SUMMARY

This report concerns the amended plans and additional information submitted to Council for an application to consolidate 16 lots, demolish all existing improvements and remediate the land followed by comprehensive redevelopment of the site to contain 246 dwellings and 1 ground floor retail premises within 4 buildings of heights varying from 3 to 8 storeys over 2 levels of parking for up to 269 vehicles combined with ancillary development works including civil works, internal road construction, tree removal and landscaping. The amended plans and additional information were submitted in response to the resolution of the Joint Regional Planning Panel (JRPP) at its meeting on 24 April 2014. The application is referred to the JRPP for determination.

1. Background

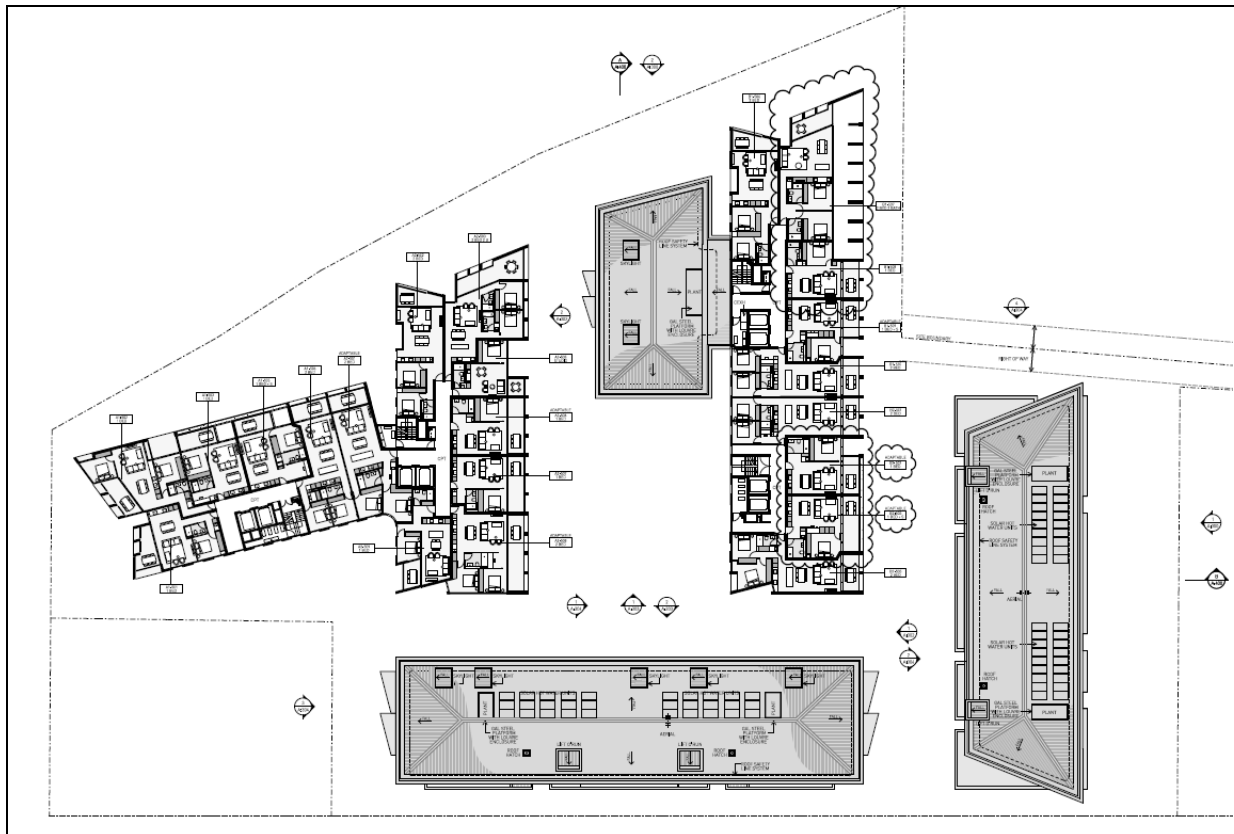
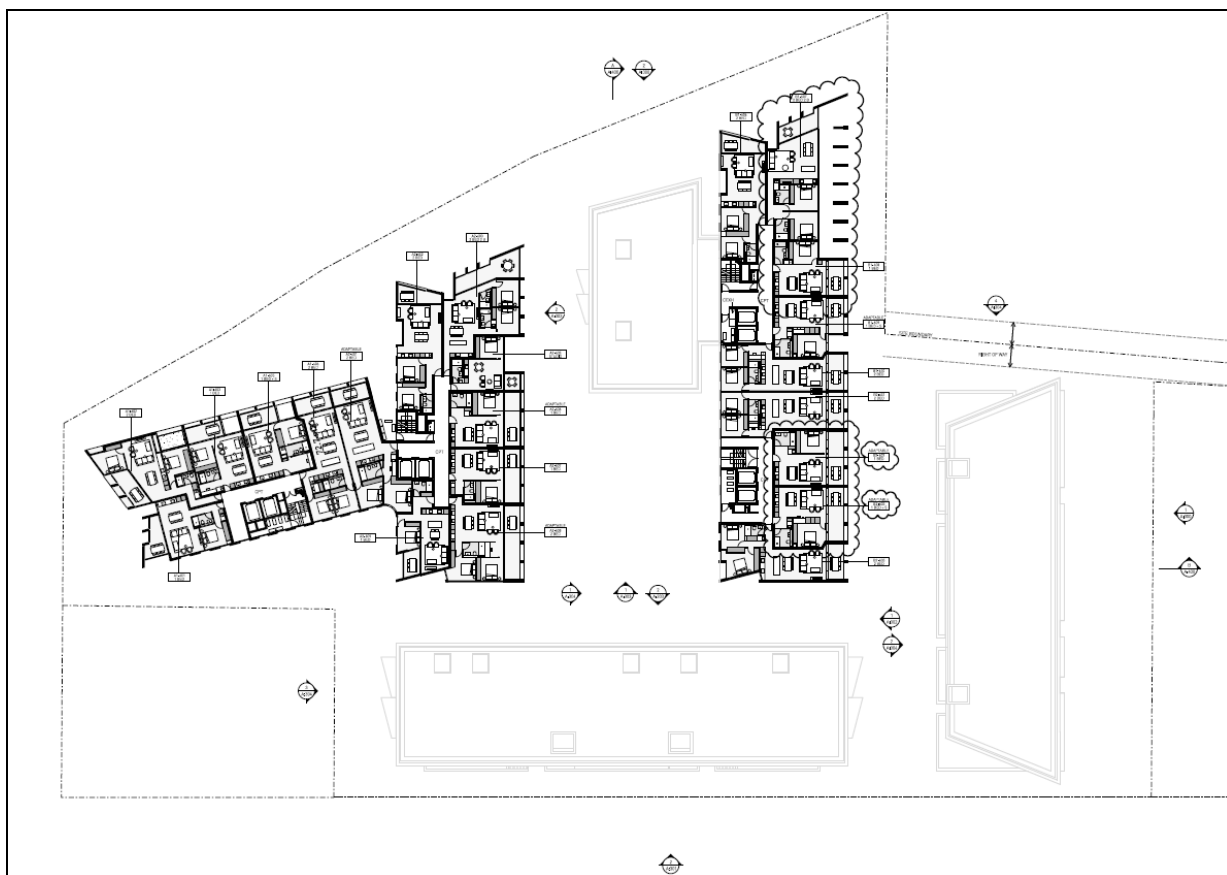
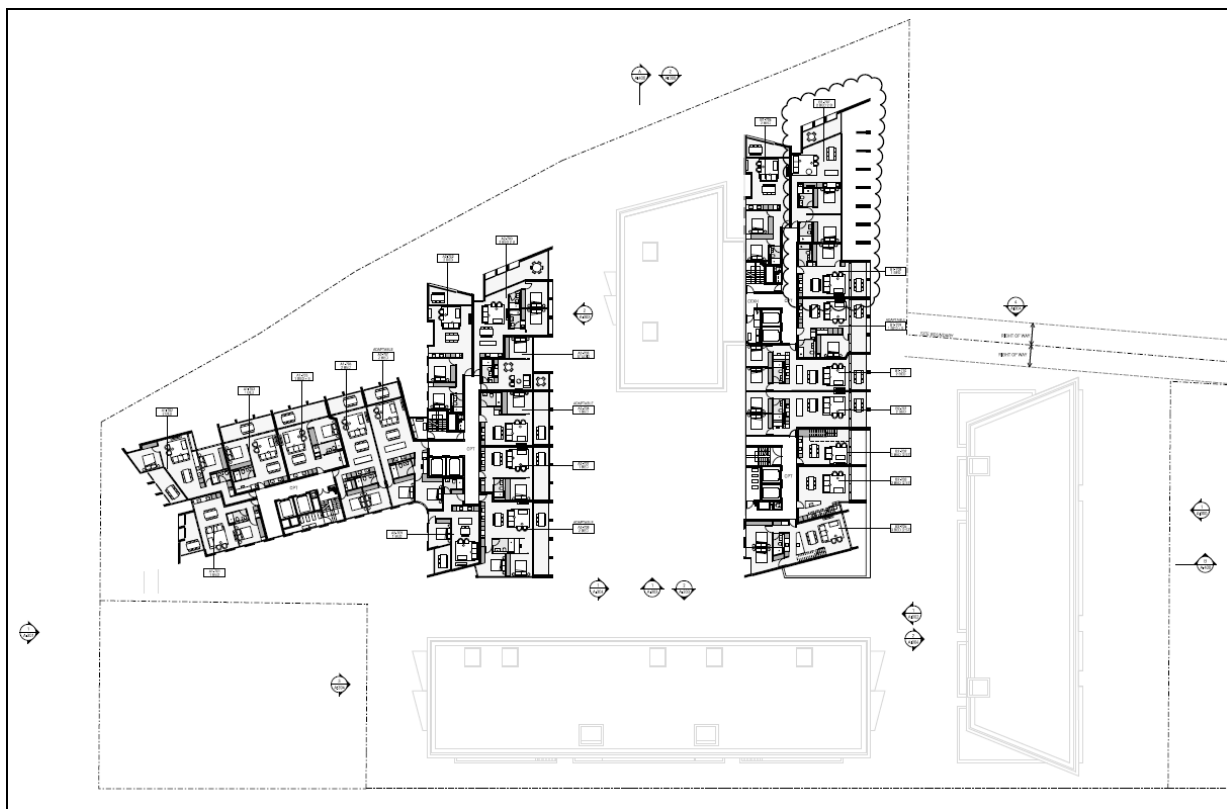
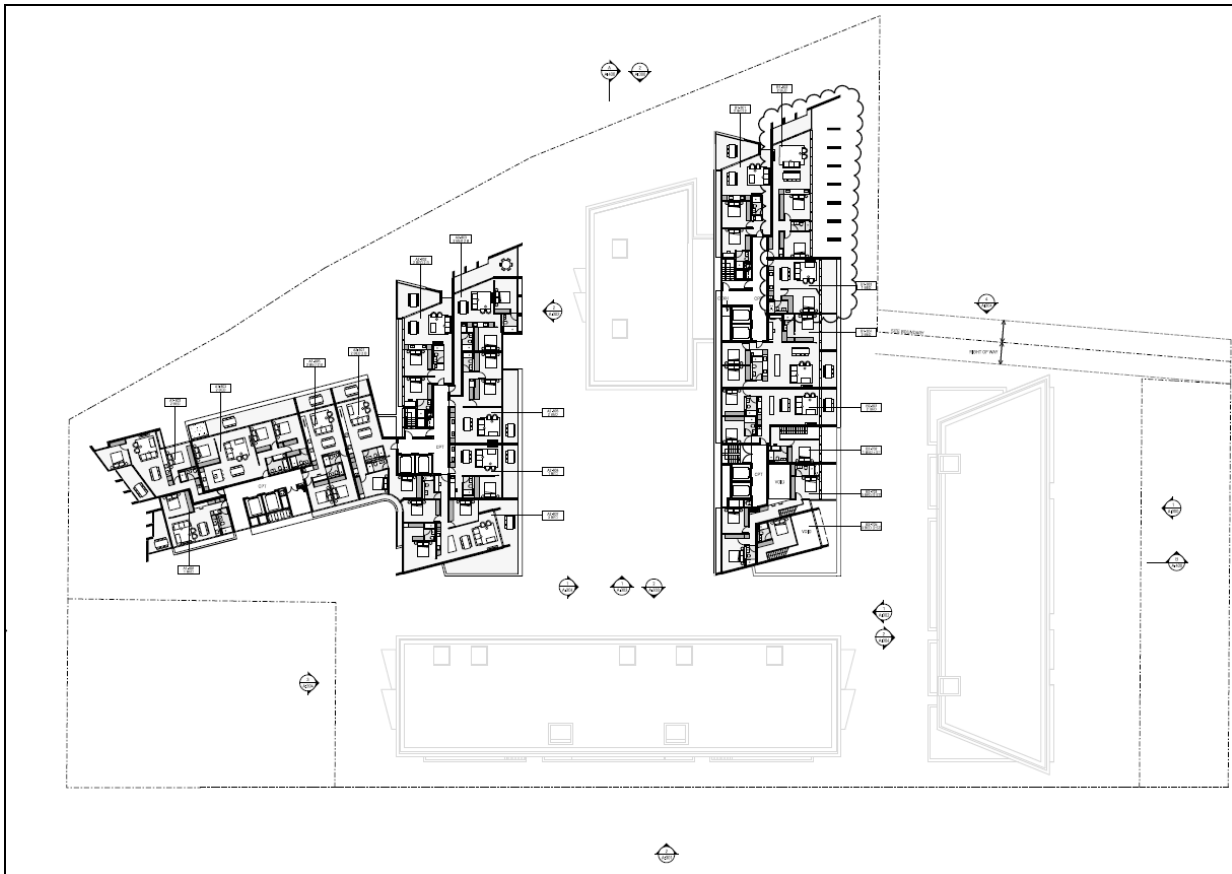
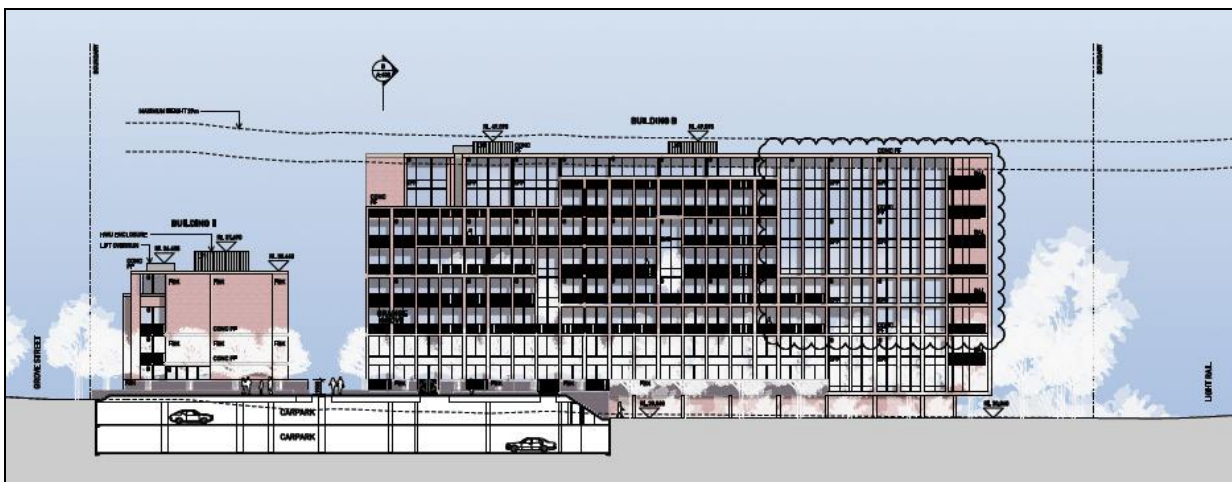
The amended plans indicate a 9 metre setback for levels 5-8 of Building B from the common boundary with the site of future Building G. It is noted that the western wall and roof of this building have not been altered and the applicant seeks to retain blade walls as an architectural feature on the northern elevation located within the 9 metre setback.

The amended drawings are considered to meet the intent of the JRPP resolution as they satisfy the objectives of the building separation requirements contained in the Residential Flat Design Code (RFDC) that accompanies State Environmental Planning Policy No. 65 – Design Quality of Residential Flat Buildings (SEPP 65).

The RFDC states that for buildings over three storeys, it is recommended that building separation increase in proportion to building height to ensure appropriate urban form, adequate amenity and privacy for building occupants. Given the subject building is 8 storeys in height the RFDC requires a setback of 18 metres between buildings to provide adequate amenity for future occupants (resulting in the 9m boundary setback required by the JRPP).

In this instance the setback is provided on the northern façade of the building. Accordingly the additional setback does not improve solar access for adjoining properties. The intent of the setback in this instance is to create an appropriate urban form and maintain adequate levels of privacy and separation. The amended proposal achieves these objectives in that the residential apartments are setback the required 9 metres (thereby achieving adequate levels of privacy), while the structures located within the setback area add depth and architectural interest to the building. The blade walls and roof also have environmental benefits as they provide shading to the glass wall of the building.

Image 7: Amended plan indicating car share spaces on North Lane

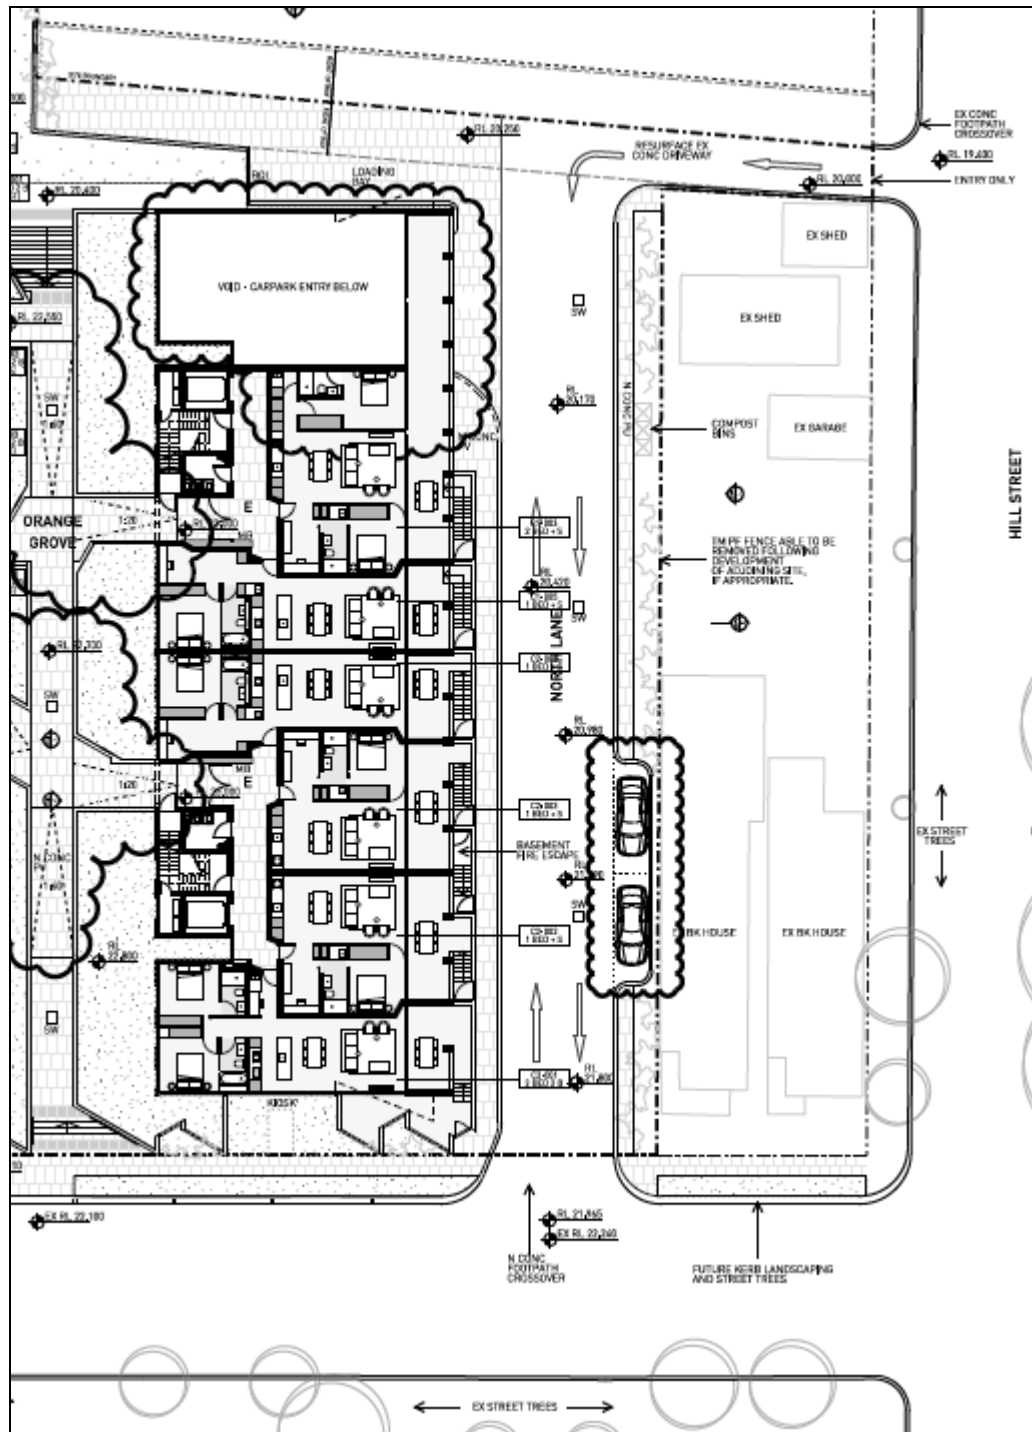
The amended plans submitted to Council on 9 May 2014 provided the 2 car share spaces in a non-secured area of the car park. The spaces were to be located directly at the base of the main entry ramp with the residential car park security door relocated to the west of the spaces to ensure they were in a non-secure area.

It is evident from the attached response that the vehicles could exit in a forward direction via a 4 point turn. However, it was agreed by both parties that the proposal was less than desirable.

While it would be preferable to locate the car share spaces in Grove Street, such a proposal would require the matter to be considered by the Councils Pedestrian, Cyclist and Traffic Calming Advisory Committee, and despite the positive evaluation on parking impact provided by Traffix, local residents may have concerns about the loss of on-street car parking.

Consequently the preferred location for the spaces is at grade and on-site and for this reason option 1b (North Lane) as contained in the letter from Traffix (Attachment 2) is recommended to the JRPP. The applicant provided an amended plan indicating this preferred location which is reproduced below:

Council's Development Engineer has reviewed the proposal and supports the relocation of the car share spaces to North Lane. Accordingly the amended basement plan submitted to Council on 9 May 2014 has not been included in the schedule of conditions as the above amended ground floor plan is recommended to the JRPP.
